Interactive comment on “TOPMELT 1.0: A topography-based distribution function approach to snowmelt simulation for hydrological modelling at basin scale” by Mattia Zaramella et al.

Mattia Zaramella et al.

Received and published: 9 July 2019

Figure 6. a) Land use distribution for the catchment and b) pixel based overall accuracy (OA) of the comparison between simulated and MODIS-derived snow cover maps, computed from January 1 to June 30, 2011 for a total of 50 MODIS snow cover maps.

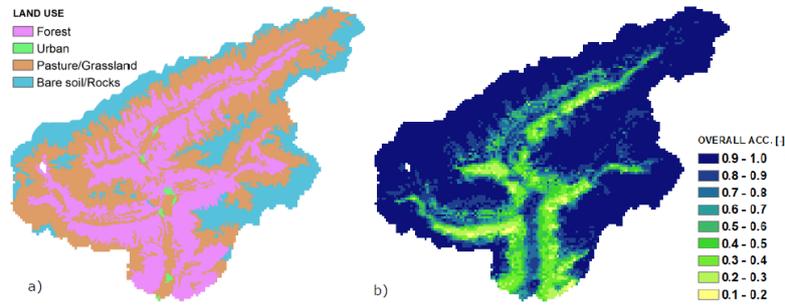
R2C4: Page 13, lines 5-8: I think coniferous forests and discontinuous vegetation might be the dominant land covers in such a catchment. Therefore, given the limits of MODIS in vegetated areas, I suggest to show the comparison between TOPMELT and MODIS for all the land covers, except for the forested areas. As an alternative, the results of the comparison could be shown in a table or in the figures, but distinguishing the various land uses.

R2C15: Page 13, line 6: Please provide the fraction for the different land uses in the description of the study area. I think coniferous forests and discontinuous vegetation might be the dominant land covers in such a catchment. Therefore, given the limits of MODIS in vegetated areas, I would suggest to show the comparison between TOPMELT and MODIS for all the land covers, except for the forested areas. As an alternative, the results of the comparison could be shown in a table or in the figures, but distinguishing the various land covers.

We thank the Reviewer for this note. As we reported in our response to comment R2C3, land use and impact of vegetation is not considered in this work. However, we recognise the limits of MODIS in vegetated areas. To account for this, the revised version includes a new version of Figure 7 (now Figure 6 in the revised version), where we report the land use distribution. The revised version includes also text reporting the fractions of different land uses. This helps understanding the impact of forested areas on OA and better interpreting our results.

See R2C3 and R2C4. In the revised version (marked-up manuscript), we added text with the fraction of different land use cover.

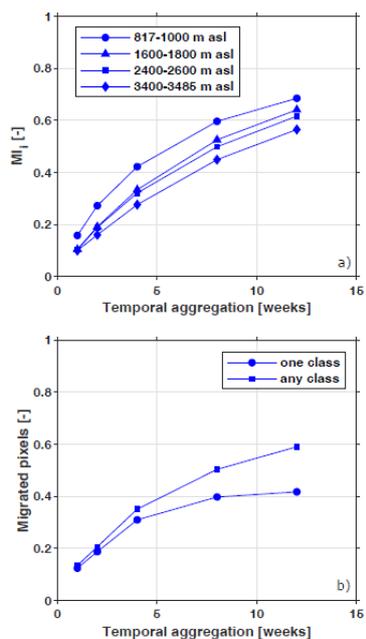
R2C13: Page 10, line 28: Maybe you could consider reporting the figure as supplementary material or as the new Figure 4, if the current one will be merged with Figure

R2C14: Fig 3-4: I think Figure 4 could be merged with Figure 3 in order to have only one figure but with two plots. Please consider this change.

We merged Figures 3 and 4 in the revised version (see the following comment R2C14).

Done, see the new Figure 3 below.

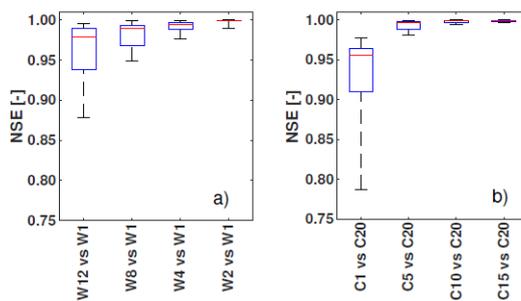
R2C18: Fig 8: Please use the same scale for NSE and add a) and b) in the two plots and the caption of the figure.

R2C19: Page 15, line 11: Why should W4-C10 be the better choice considering ac-

curacy and computational efficiency? Based on Figure 8, I would choose W2-C10. Please explain the sentence (your choice) and especially from the computational efficiency point of view.

Done, see below revised Figure 7.

For this case study, results obtained with the finest spatial and temporal aggregation are similar to those obtained with an intermediate configuration (W4-C10), despite W2-C10 performs better. TOPMELT, in its W4-C10 configuration, computes the snowpack model for 10 points (classes) and updates the radiation 12 times a year; on the other hand, the W1-C20 configuration performs double the load for computing the snowpack (20 classes) and updates the radiation distribution four times more (48 times a year). Therefore, an intermediate resolution represents a balance between computational efficiency and accuracy. We added this to the revised paper.
